Submission of Further Information (FI)

**Proposed Temporary Public Vehicle Park (Excluding Container Vehicle) and
Associated Filling of Land for a Period of 3 Years in "Village Type Development"
and "Agriculture" Zones, Various Lots in D.D. 9, Yuen Leng, Tai Po, New Territories**
(Application No.: A/NE-KLH/658)

Further Information for Planning Application No. A/NE-KLH/658**Response-to-Comments****Comments from the Drainage Services Department**

Plan 5.2
(P 25046)

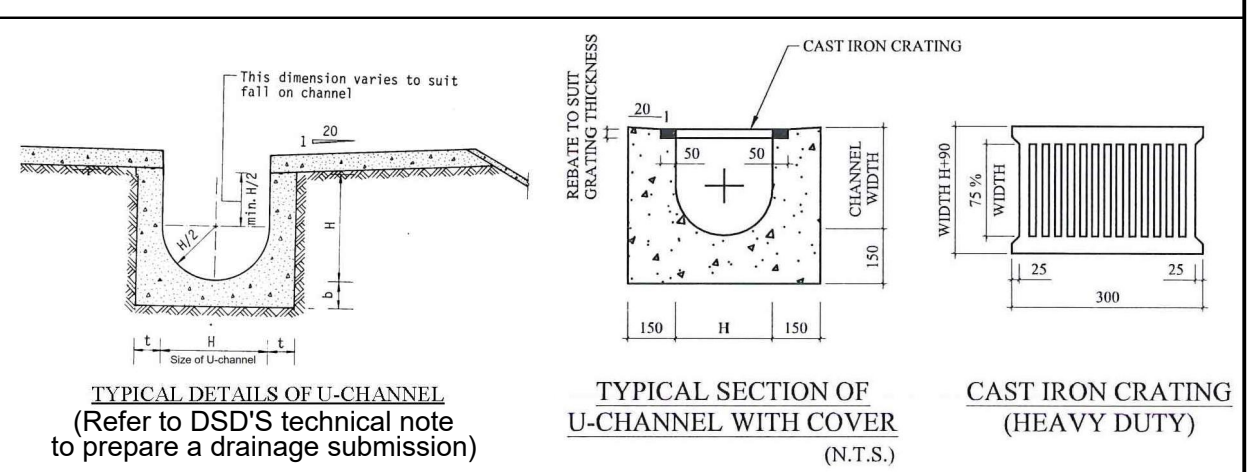
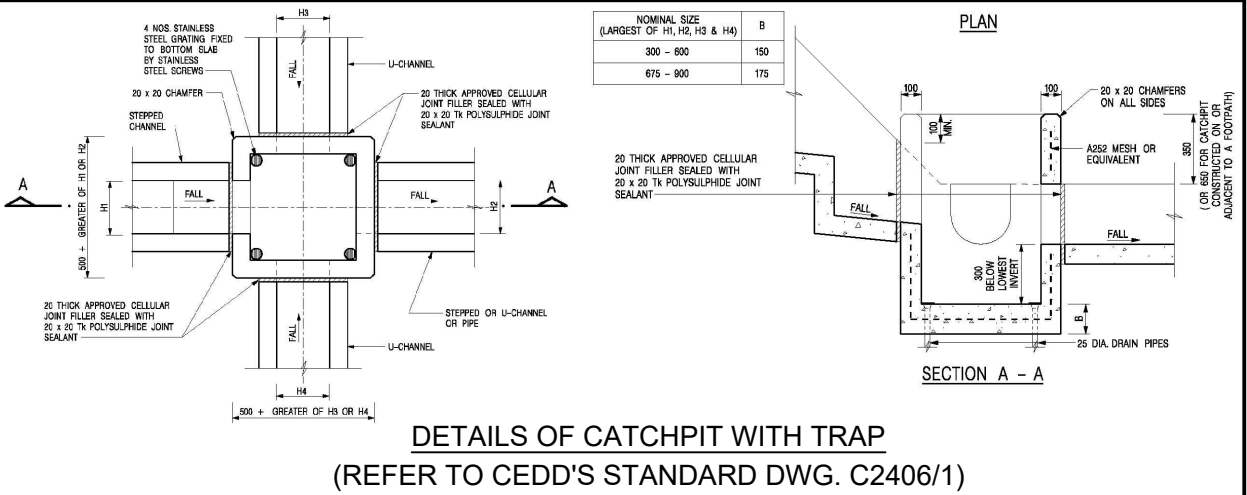
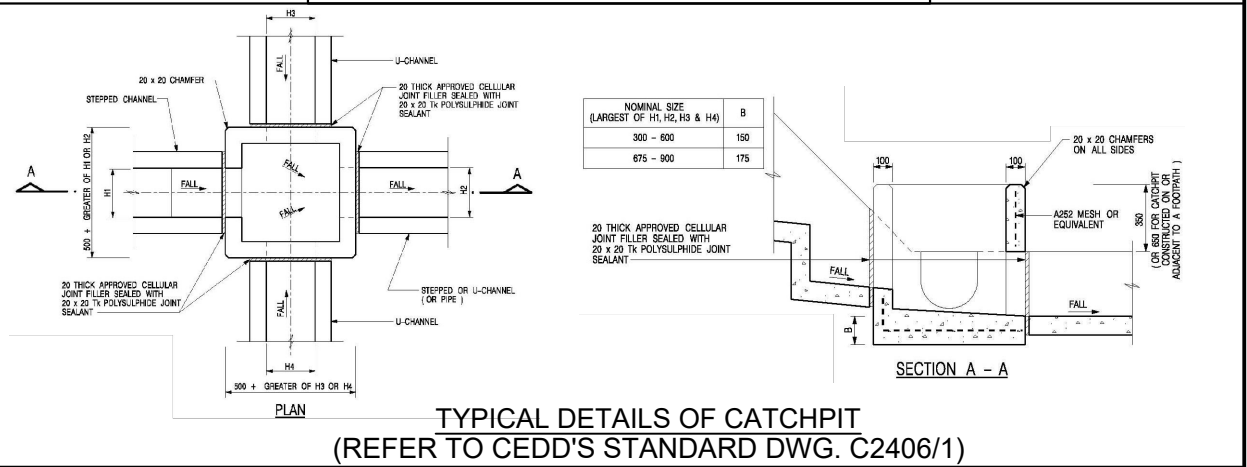
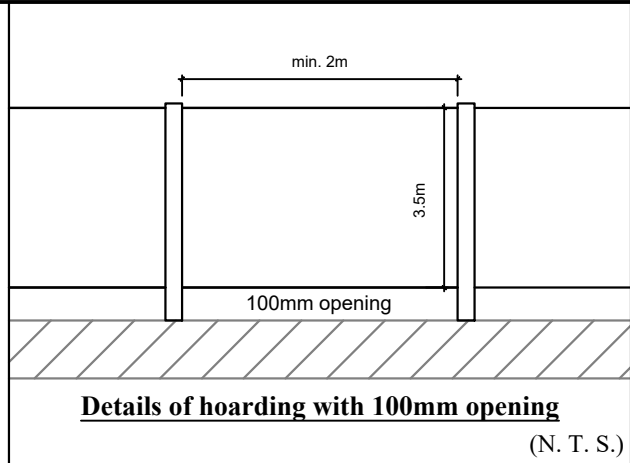
I.	Comments	Responses
1.	I have reservation on the subject application as there is landfilling works to be carried out at the application site which may cause adverse drainage impact to the surrounding lands and premises. As such, the applicant is required to provide further information to demonstrate that the development will not cause adverse drainage impact to the adjacent areas.	Please see the drainage proposal (Plans 5.1 & 5.2) and hydraulic calculations for details.
